TULSA METROPOLITAN UTILITY AUTHORITY

March 27, 2023

**ADDENDUM NO. 1
TO
PROJECT NO. TMUA ES-2023-SOM4
CLEANING AND VIDEO INSPECTION OF SANITARY SEWER SYSTEM**

306 RAISE MANHOLES TO GRADE

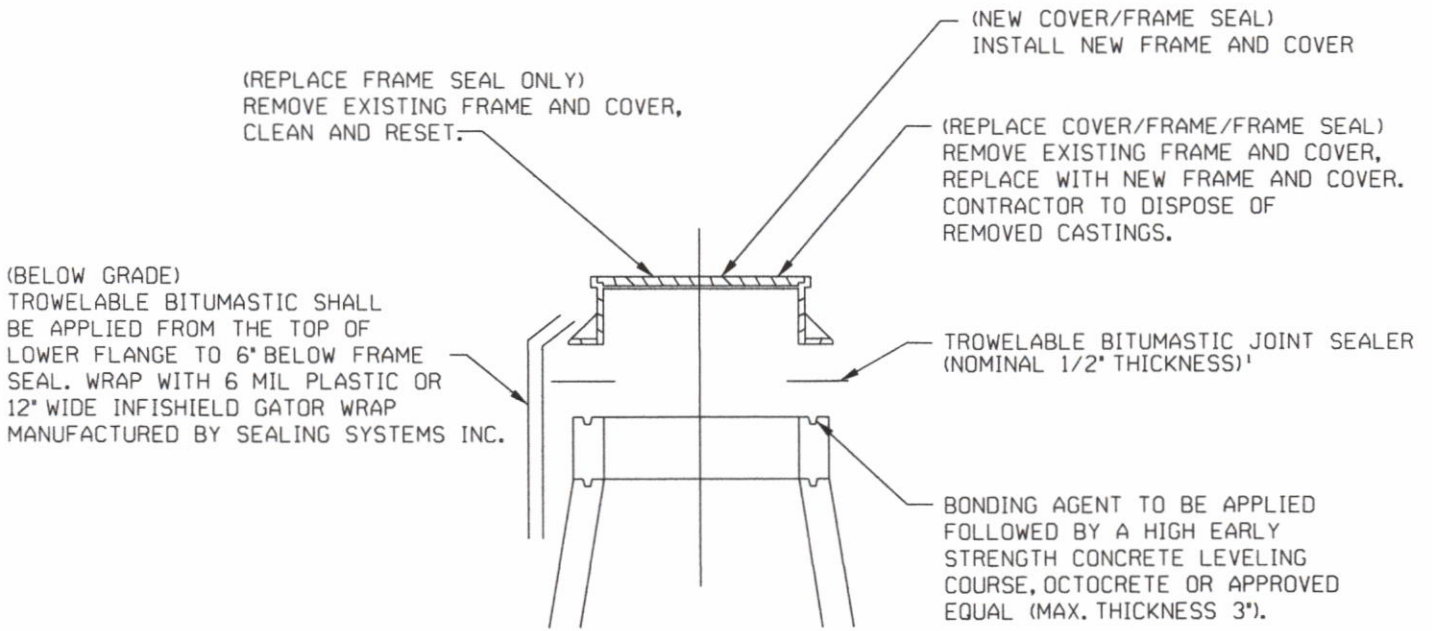
306.1 The Contractor shall perform this work on such manholes as recommended in writing by the Authority's Representative. The request for such work shall originate from Contractor-submitted forms. Said work shall be performed on manholes so that the finished-to-grade lid to top of corbel distance is less than 16 inches.

- A. Manhole lid elevation adjustments of less than 6” shall be completed using metal adjustment rings. Trowleable bitumastic shall be used between each ring and between the bottom ring and the manhole frame. No more than two metal adjustment rings may be used on one manhole. Metal adjustment rings will be provided to the contractor by the City.

- B. Manhole lid elevation adjustments from 6” to 16” shall be completed using plastic riser rings manufactured by Cretex or approved equal. The Contractor shall seal between riser rings and between the top riser ring and the frame (casting) per the riser ring manufacturer’s instruction. The bottom riser ring shall be sealed to the manhole using trowelable bitumastic at a 1/2” nominal thickness (alternatively, this seal may be completed with two rings of bitumastic rope or two rings of M1 adhesive as approved by the Engineer). The outside of the riser rings and frame (from the lower frame flange to 6” below the bottom riser ring) shall have trowelable bitumastic applied and subsequently be wrapped with 6 mil plastic. Riser rings will be provided to the contractor by the City.

306.2 Measurement: The length of the raise shall be determined by measuring from the top of the manhole structure to the top of the manhole rim before work commences and again after the manhole has been raised and taking the difference of the two measurements.
